RFI

RFI #: 175
Date: 7/27/2012
Job: EB-02 Keller Springs Lofts
Phone: 877-777-5115

Subject: Air handlers and CFM columns

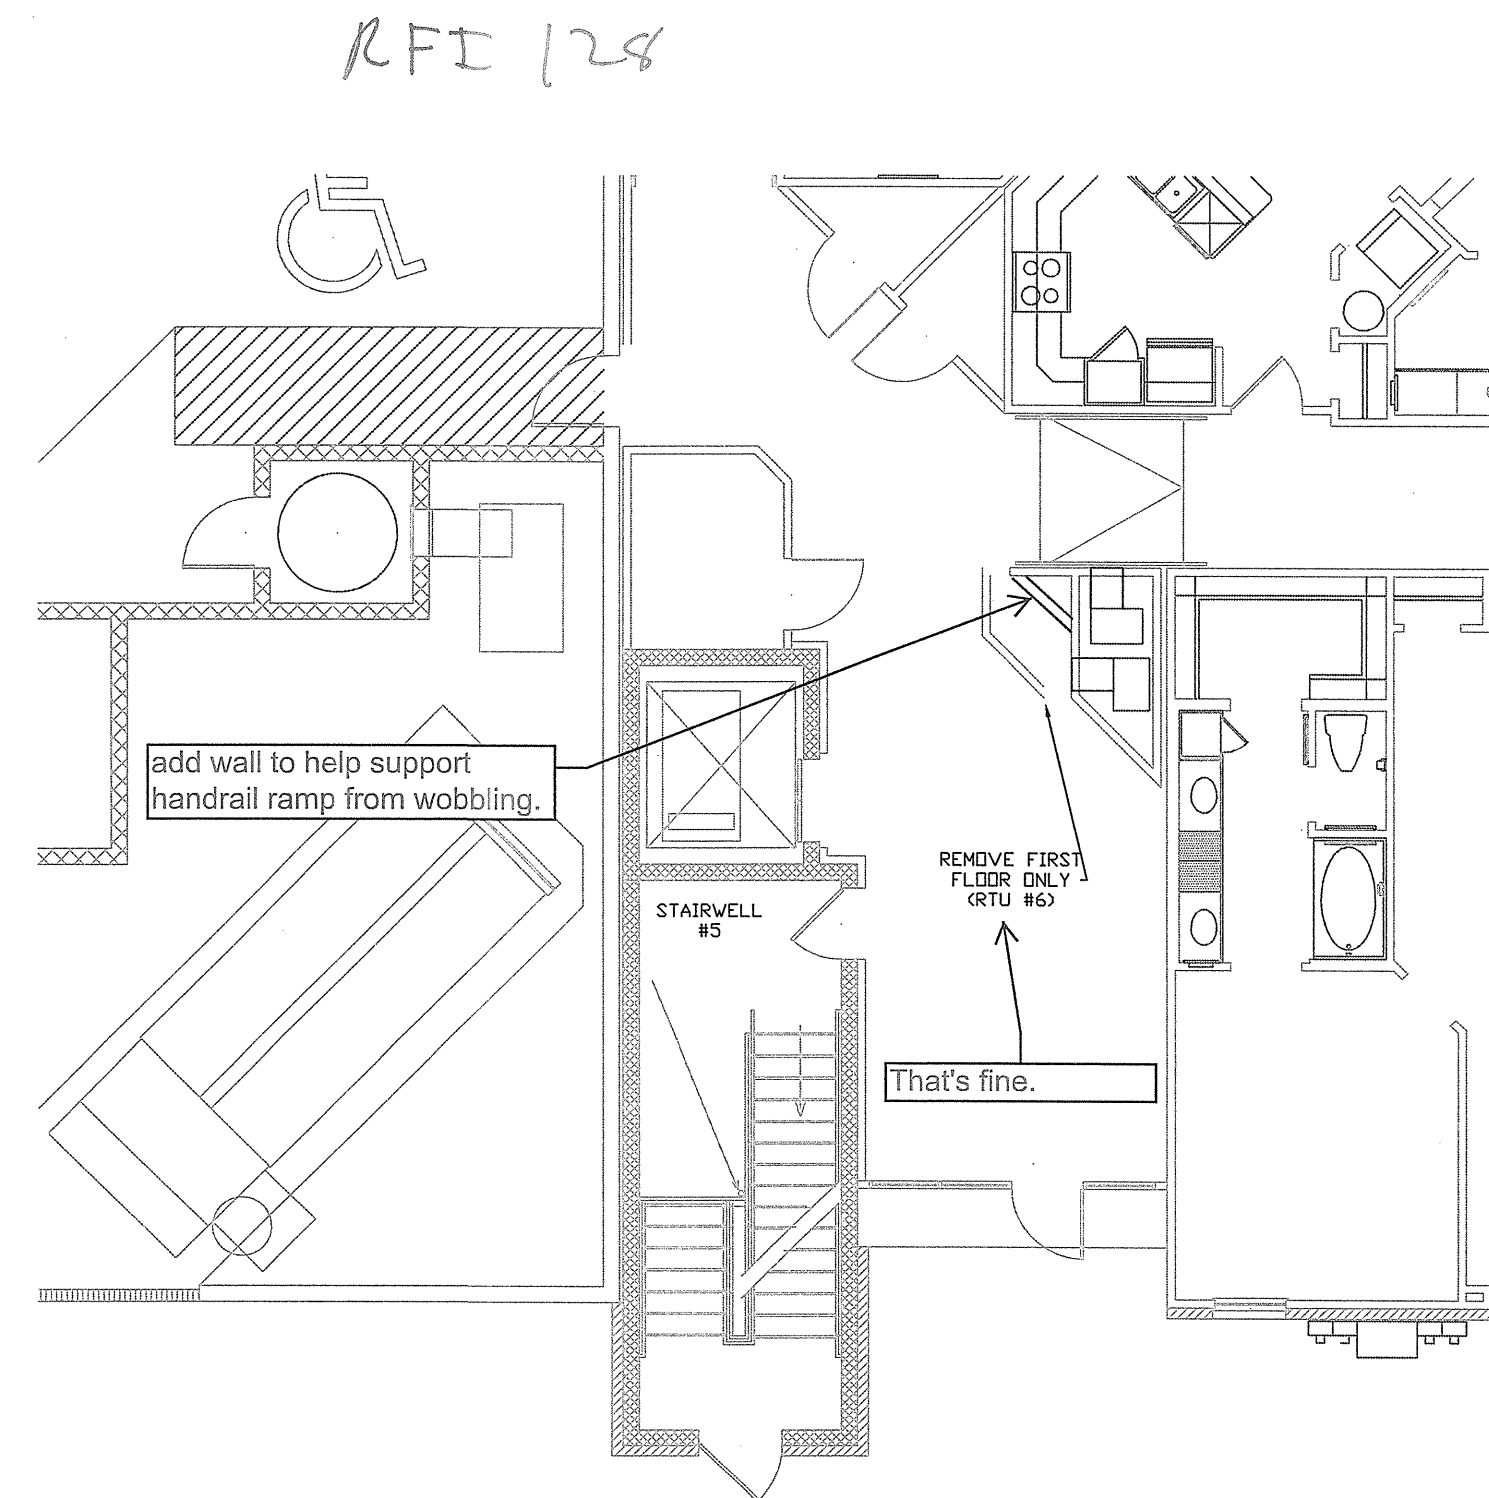
- The curved corridor wall at section C needs to be flat or have flat areas to mount the grilles.
- The corridor wall at the shaft works well on floors 2-4 but changes on the first floor and creates a problem. Suggest using the upper floor configuration on the first floor.

4 ELEVATOR MECHANICAL ROOM
 SCALE: 1/4" = 1'-0" RFF 66

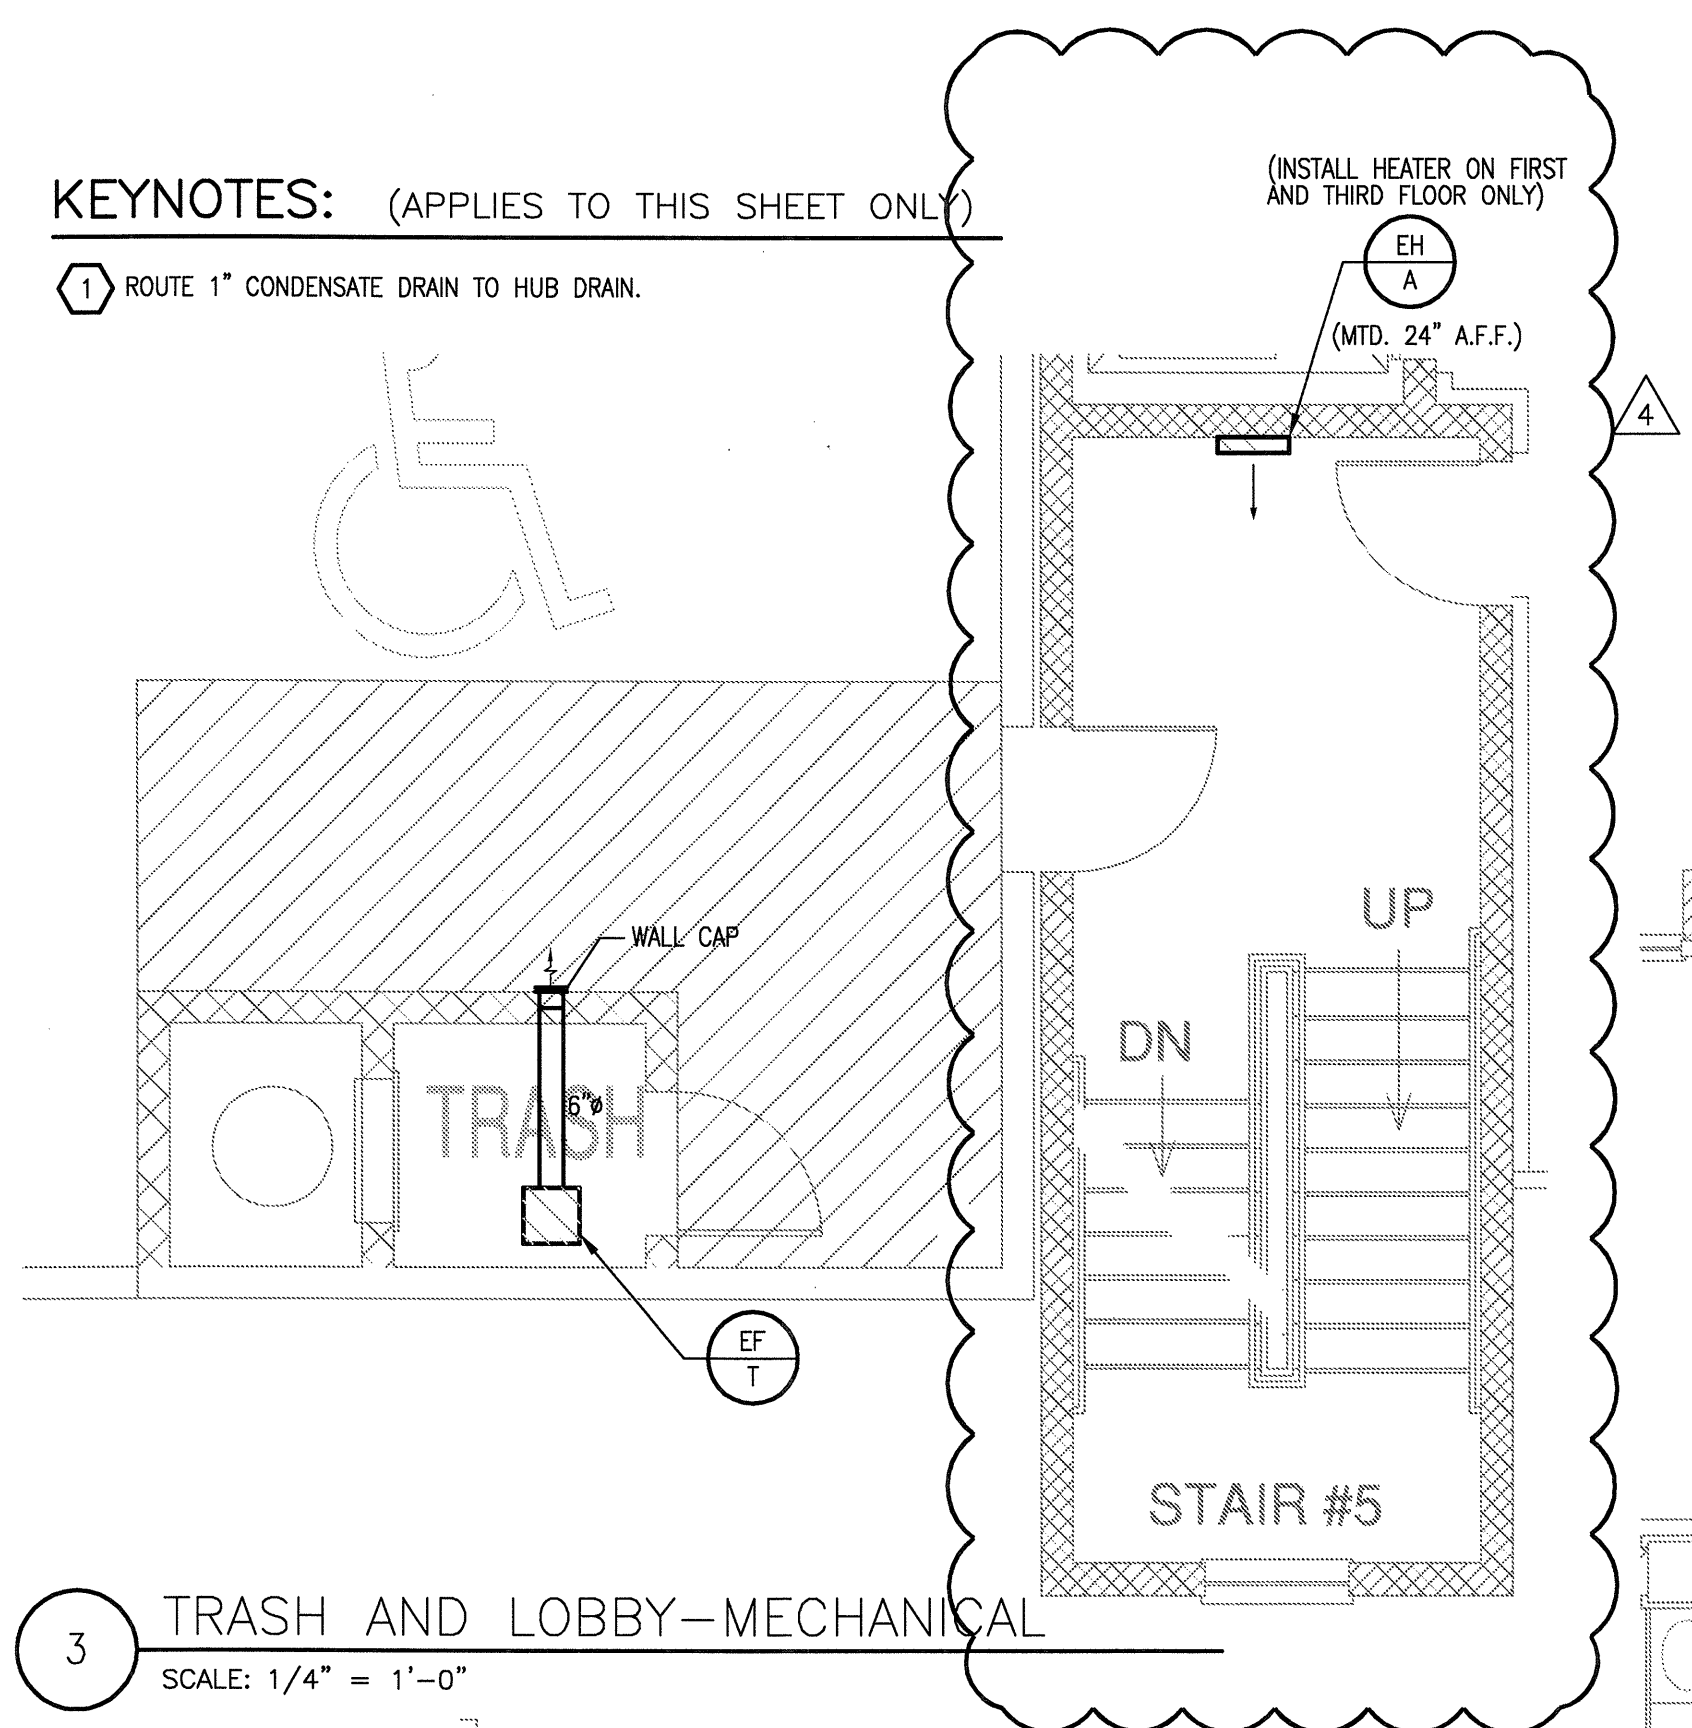
- Should we eliminate the two ductless split system for the two rooms designated EMR? These rooms are shown on sheets M-4.2, detail #4 and M-9.1.
- Is there now a requirement for HVAC at the elevator shaft? See item #26 on the attached information supplied by Jay.
